Grossmont Union High School District

GROSSMONT KITCHEN AND WEIGHT ROOM MULTI PRIME CN-2982 THROUGH CN-2991

Addendum No. 4

ADDENDUM NO. 3

ELECTRICAL YARD GATE

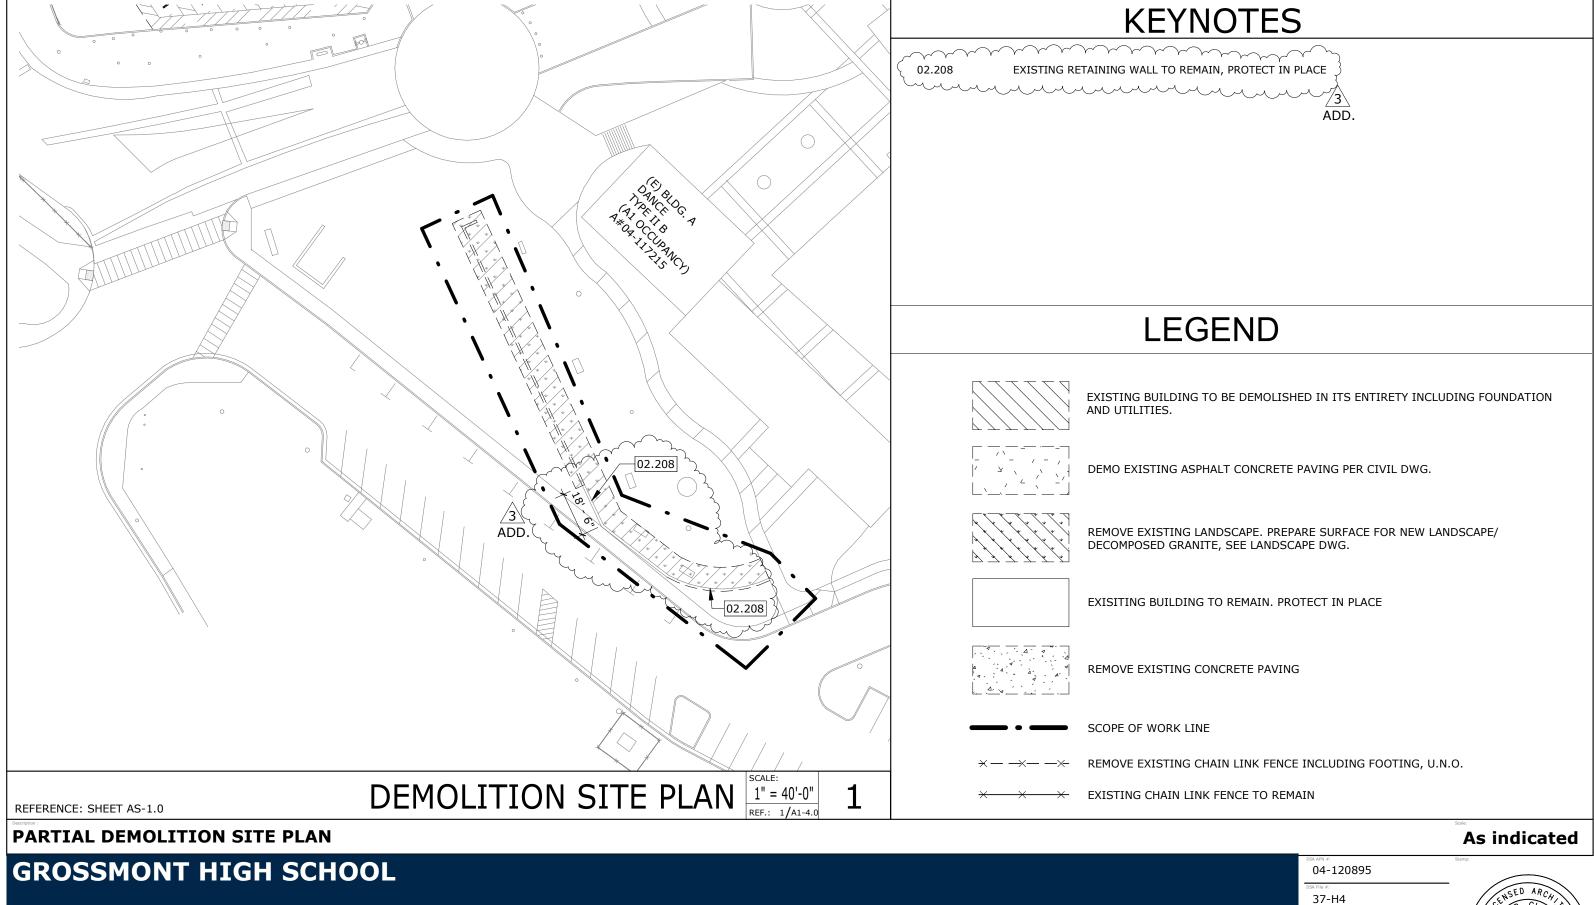
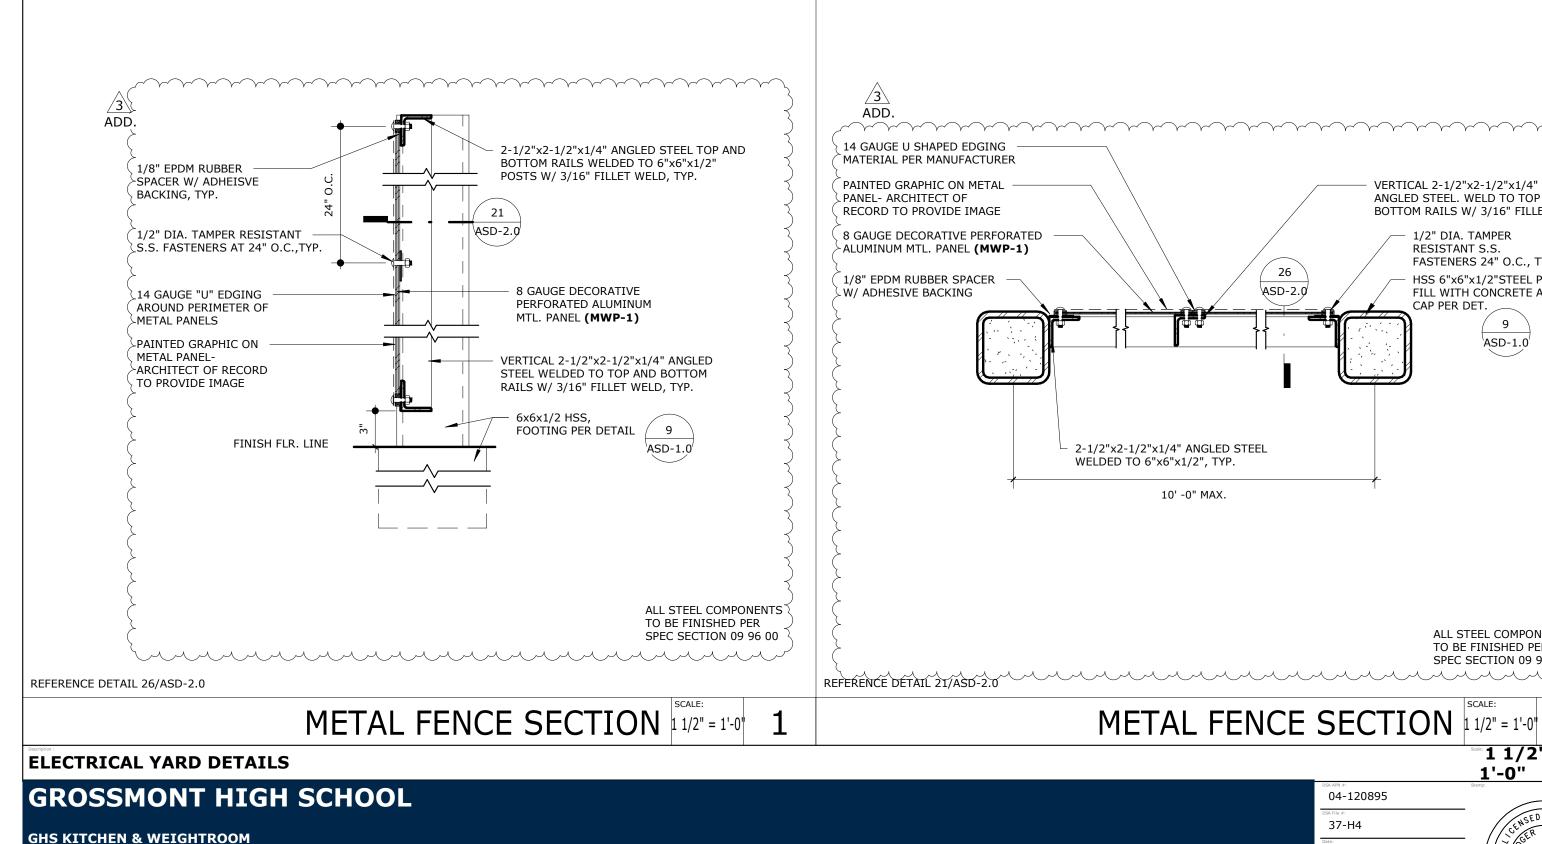
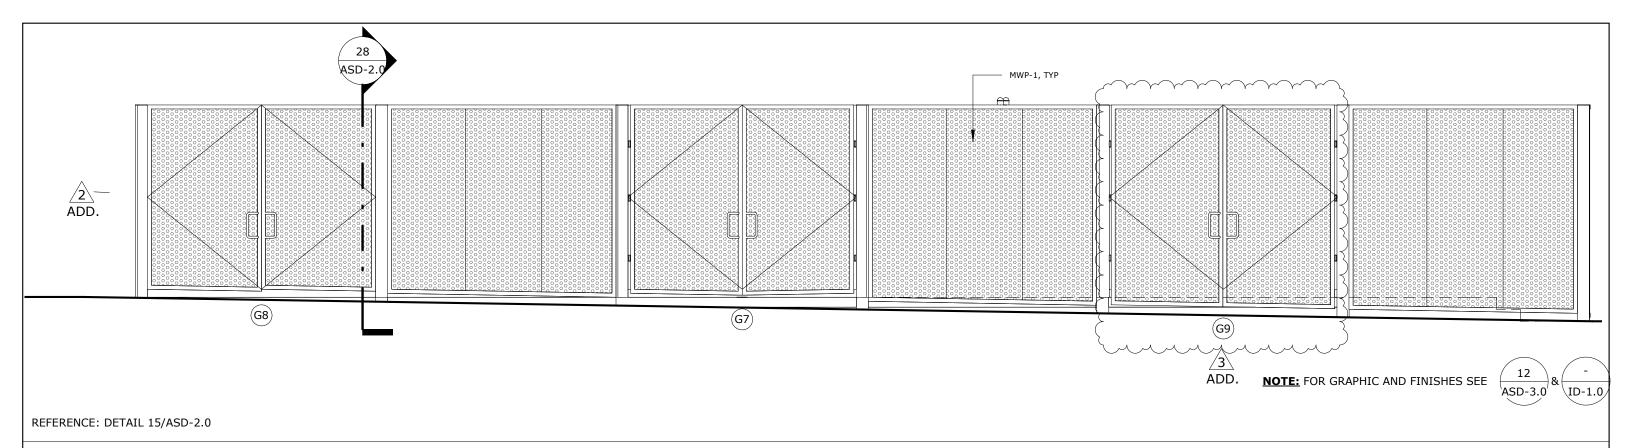
Item No. 3.13 3.13.1	Reference Sheet LP-2 – Planting Plan/ Legend Replace Sheet LP-2 with attached Revised Sheet LP-2
Item No. 3.14 3.14.1 3.14.2. 3.14.3	Reference Sheet ASO.2- Code/ Egress Site Plan Added New Gate G9 at Electrical Yard and update Gate Schedule per attached Sketch ASK-3.1 Added New Fire Lane Concrete paving sections callouts per attached Sketch ASK-3.1 Added new File Lane Conc. Paving Section per attached Sketch ASK-3.19

Item No. 3.16 3.16.1 3.16.2 3.16.3	Reference Sheet ASD-2.0– Site Details Added new gate G9 to Electrical Yard per attached Sketch ASK- 3.1 Revised Perforated metal fence detailing per attached Sketch ASK-3.3 Updated Electrical Yard Elevation to show new gate per attached Sketch ASK-3.4

REFERENCE DETAIL 2/A1-5.1

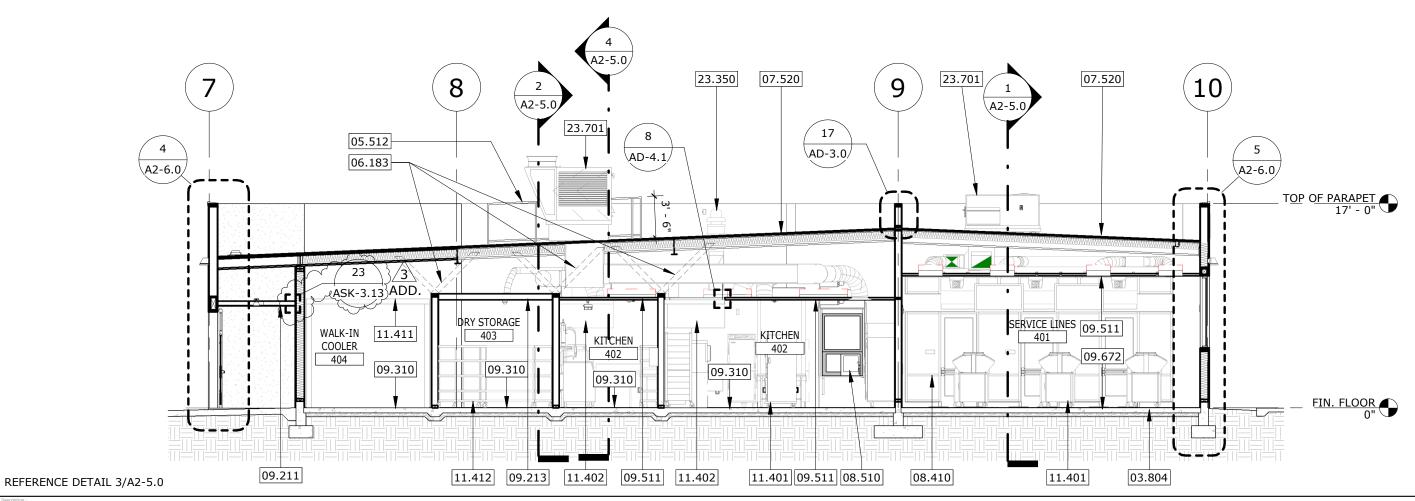
Item No. 3.17 3.17.1	Reference Sheet A1-5.1 – Building 900 Building Sections Added additional detail references to detail 2/A1-5.1 per attached Sketch ASK-3.5

ASK-3.6

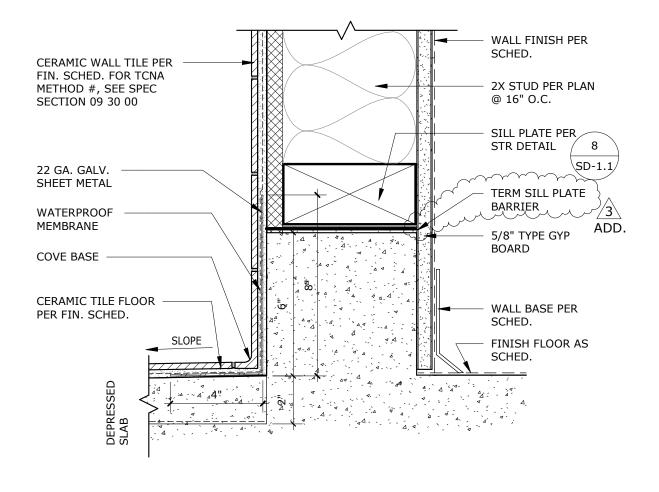
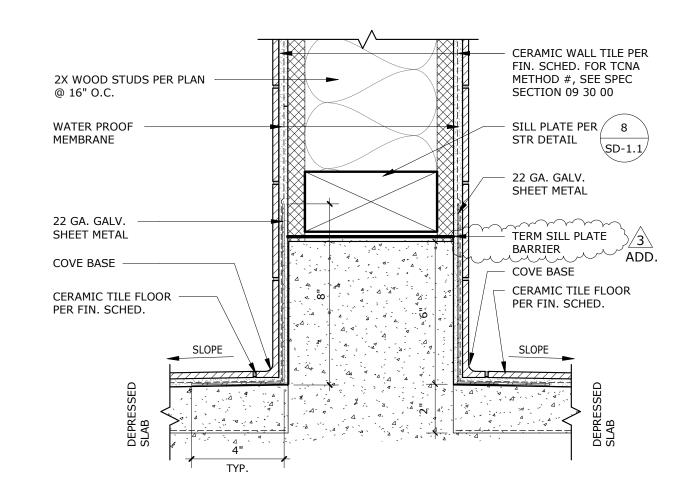
Item No. 3.18 3.18.1	Reference Sheet A2-1.0 – Building 400 New Food Service Floor & Clg Plans Replace Sheet A2-1.0 with attached Revised Sheet A2-1.0
Item No. 3.19 3.19.1	Reference Sheet A2-5.0 – Building 400 Building Sections Added additional detail reference to detail 3/A2-5.0 per attached Sketch ASK-3.6

WALL DETAILS

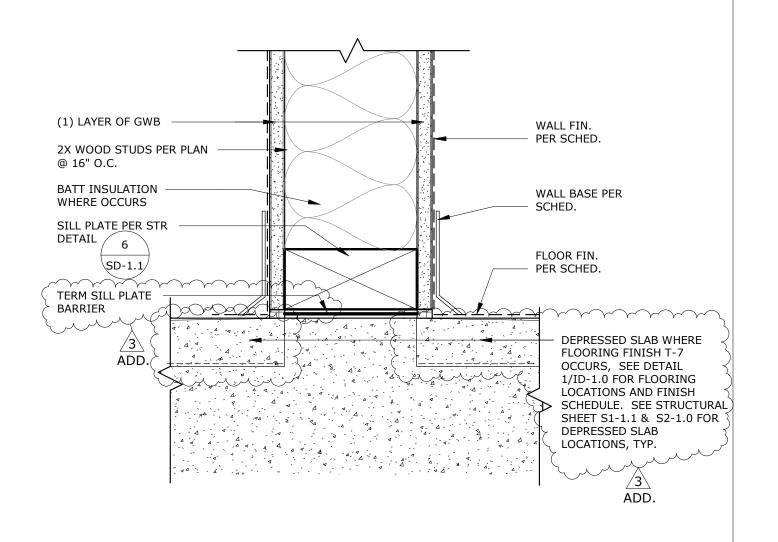
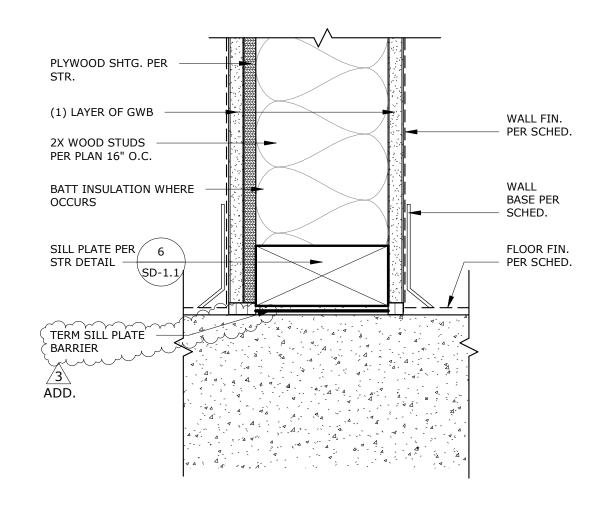
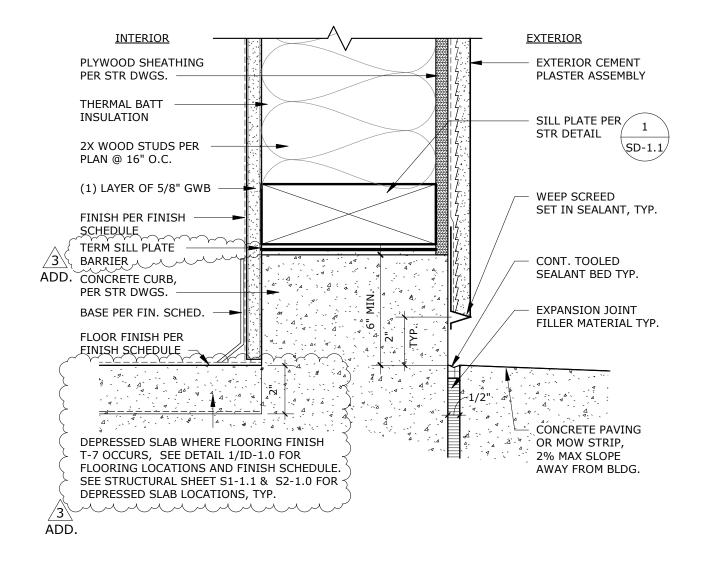
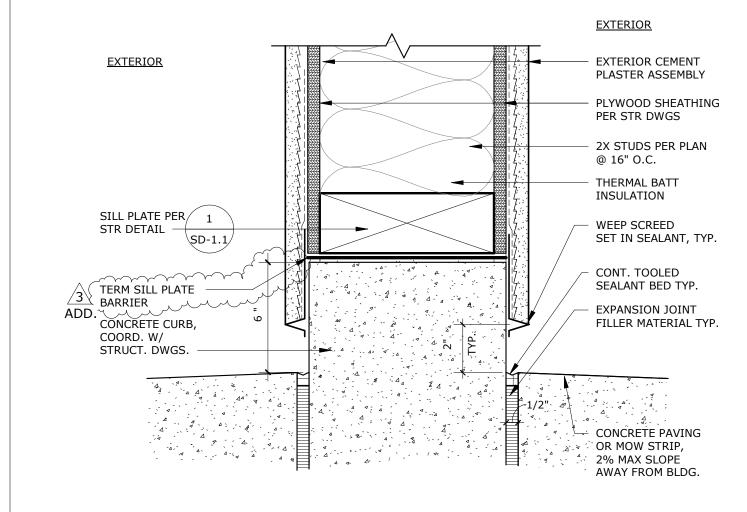
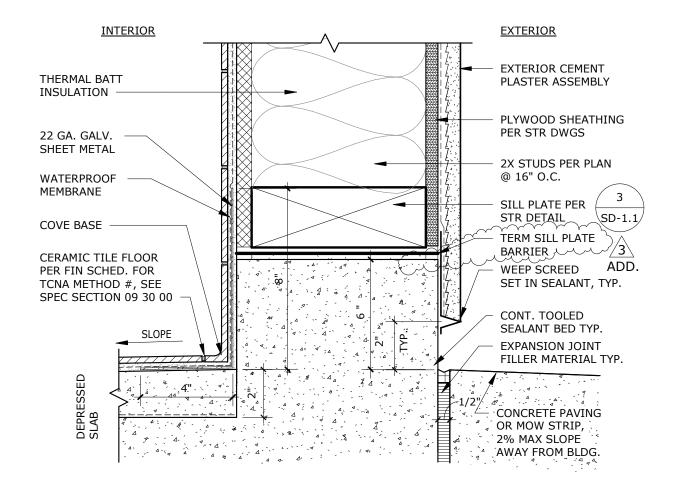
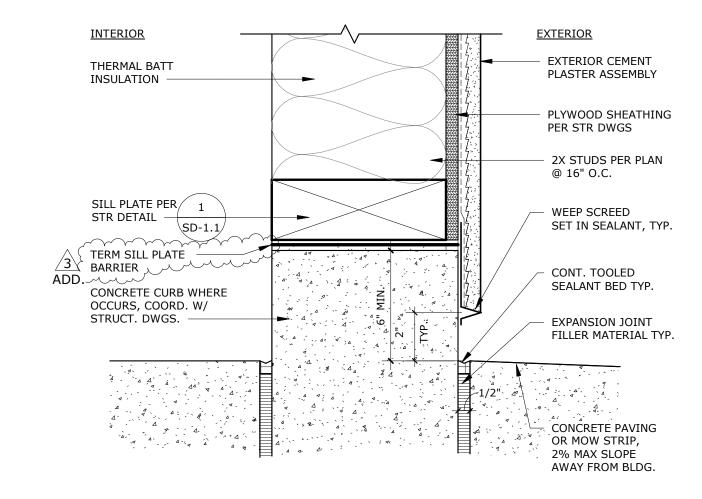
Item No. 3.20 3.20.1	Reference Sheet AD-2.0- Details Wall Types Revised Wall base details per the attached Sketches ASK-3.7, ASK-3.8, ASK-3.9, ASK-3.10, & ASK-3.12

REFERENCE: DETAIL 1/ AD-3.1

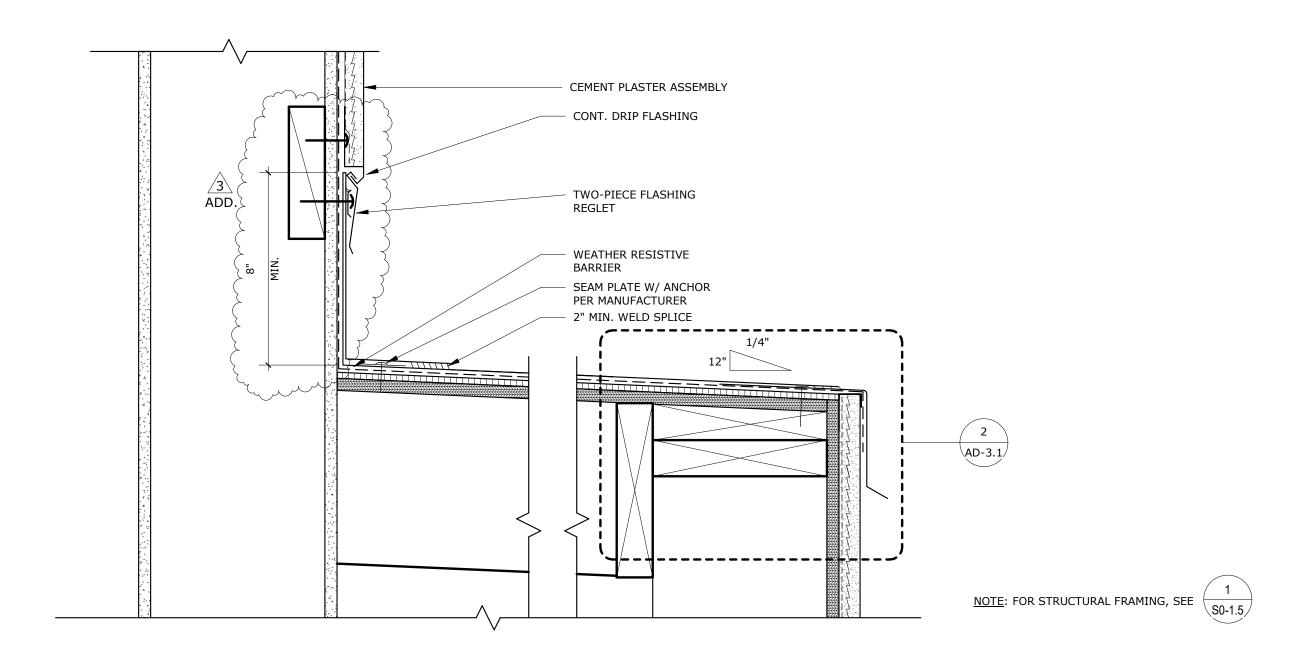
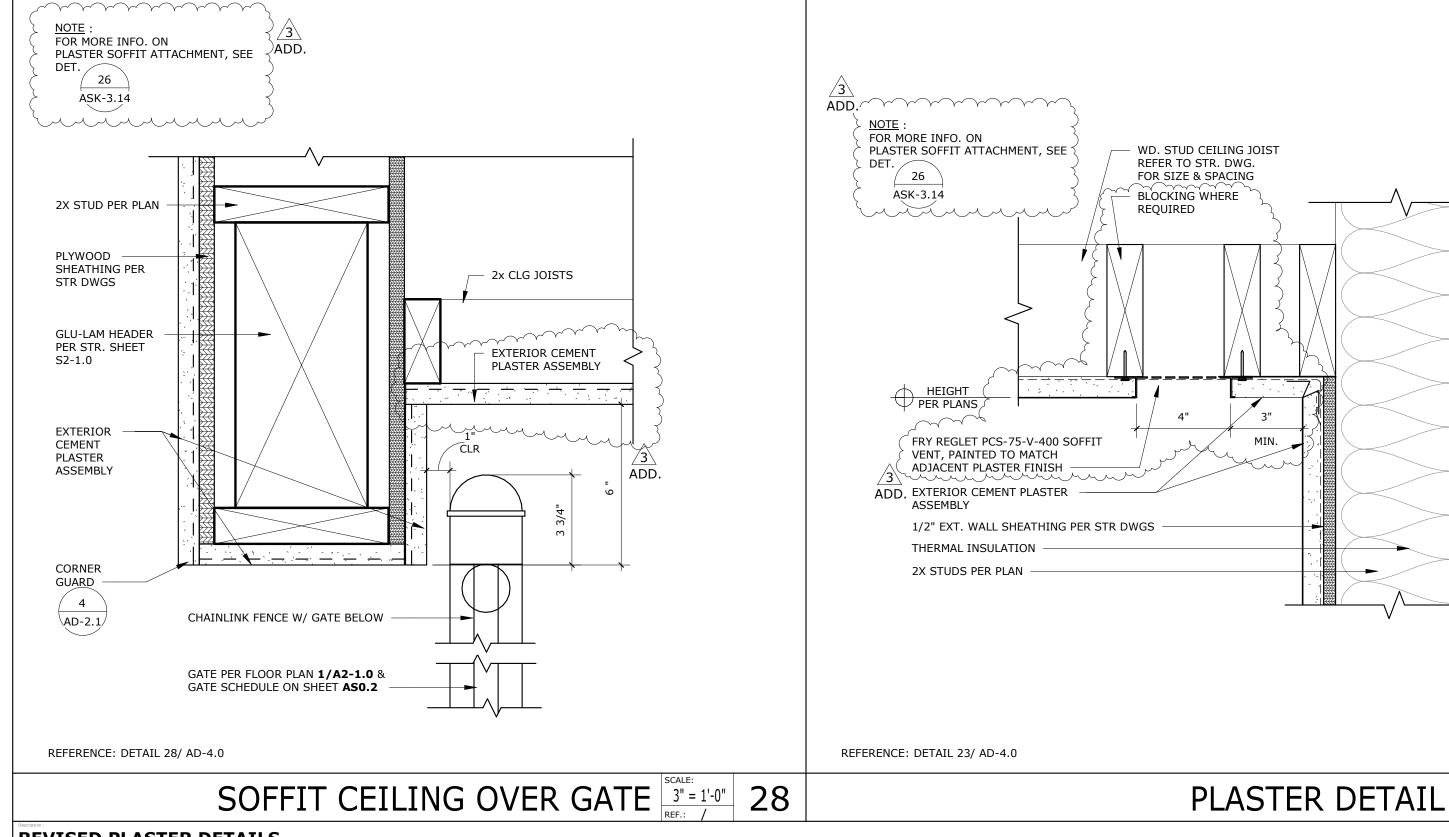
Item No. 3.21 3.21.1	Reference Sheet AD-2.1- Wall Details Added to Metal Lath Details see attached Sketch ASK-3.16
Item No. 3.22 3.22.1	Reference Sheet AD-3.1- Roof Details Revised Detail 1/AD-3.1 per the attached Sketch ASK-3.12
1tem No. 3.23 3.23.1 3.23.2 3.23.3 3.23.4	Reference Sheet AD-4.0- Details Ceiling Details Revised Detail 23/AD-4.0 per the attached Sketch ASK-3.13 Revised Detail 28/AD-4.0 per the attached Sketch ASK-3.13 Revised Detail 24/AD-4.0 per the attached Sketch ASK-3.14 Revised Detail 26/AD-4.0 per the attached Sketch ASK-3.14

REFERENCE: DETAIL 1/AD-4.1

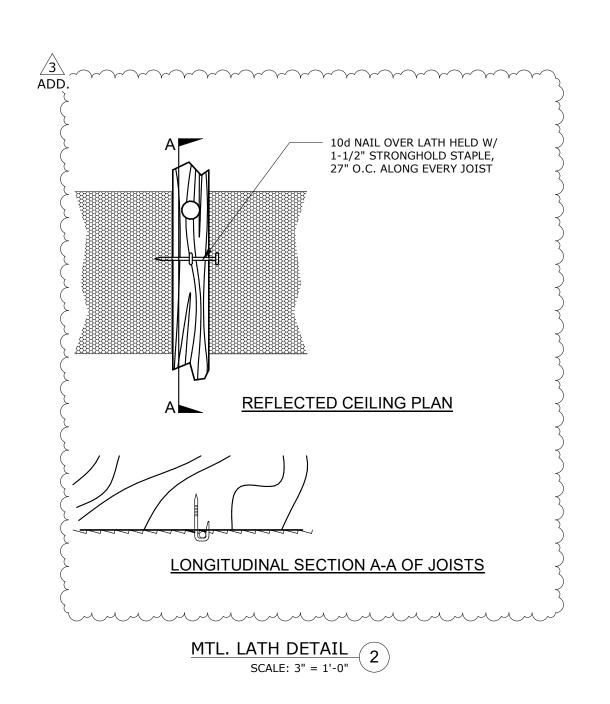
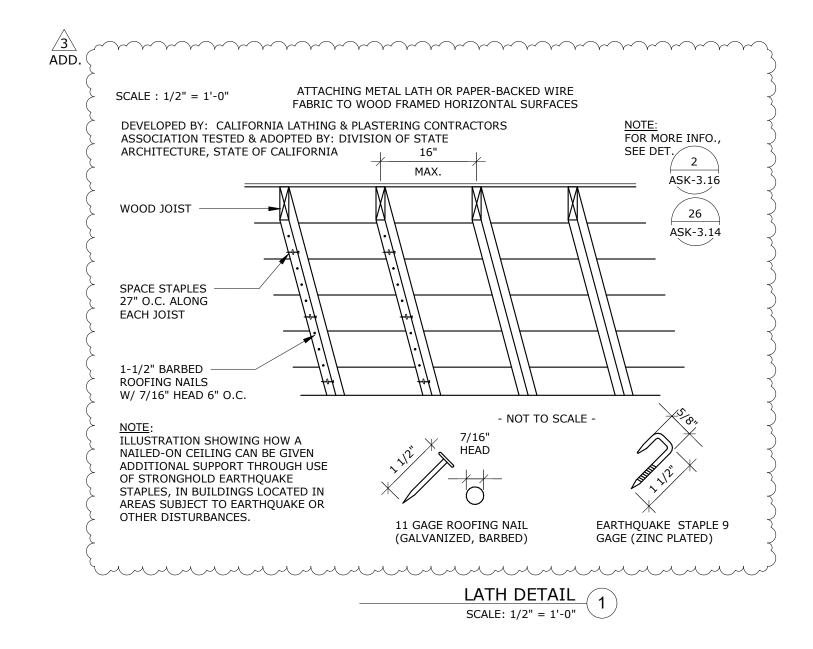
Item No. 3.24 3.24.1	Reference Sheet AD-4.1- Ceiling Details Revised Detail 1/AD-4.1 per the attached Sketch ASK-3.15
Item No. 3.25 3.25.1 3.25.2 3.25.3	Reference Sheet AD-8.0- Miscellaneous Details Revised Detail 28/AD-8.0 per the attached Sketch ASK-3.17 Revised Detail 29/AD-8.0 per the attached Sketch ASK-3.17 Revised Detail 26/AD-8.0 per the attached Sketch ASK-3.18
